MODEL NAME / TITLE Bodymedia (MTP)		REV 2.0.3
SCALE 1:1	DRAWING NO. HW-SCH-FL297AT2.0.3	PROJECT FL-297	SHEET 1 OF 1	SIZE Custom
JAS / CBMD		Enter Name Here	RBR	
DESIGNED (yyyy-mm-dd)		CHECKED	APPROVED

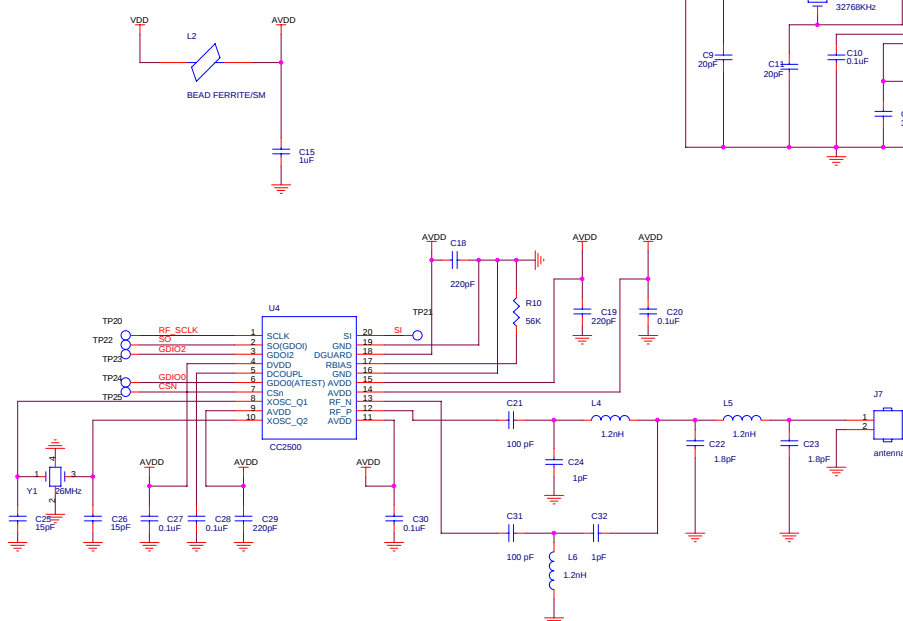
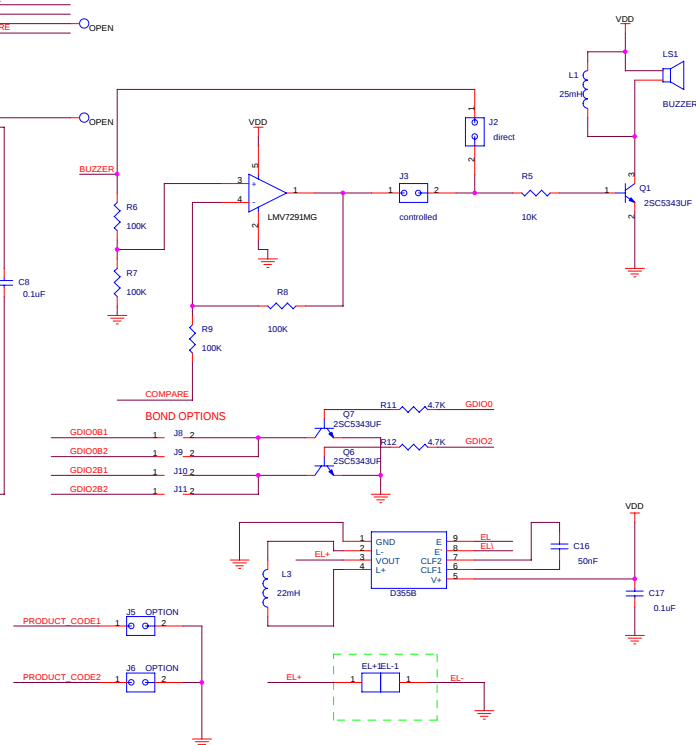
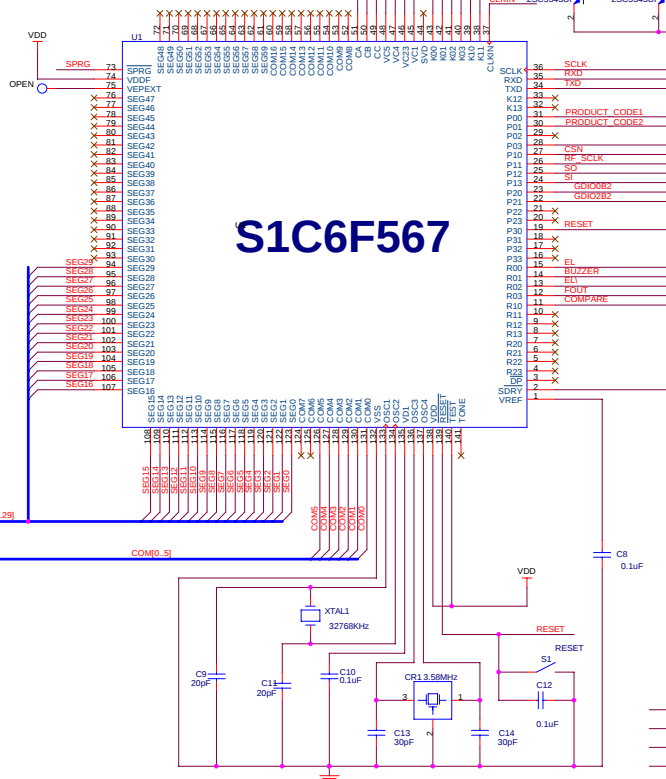
REVISION HISTORY	
REV. NO.	DESCRIPTION
2.0.1	Changed the value of C21 and C31 from 0.1uF to 100 pF
2.0.2	Removed the label RST in pin 28 of U1 Changed the value of R11 and R12 from 100K to 4.7K
2.0.3	Modified the pin arrangement for the programming port.
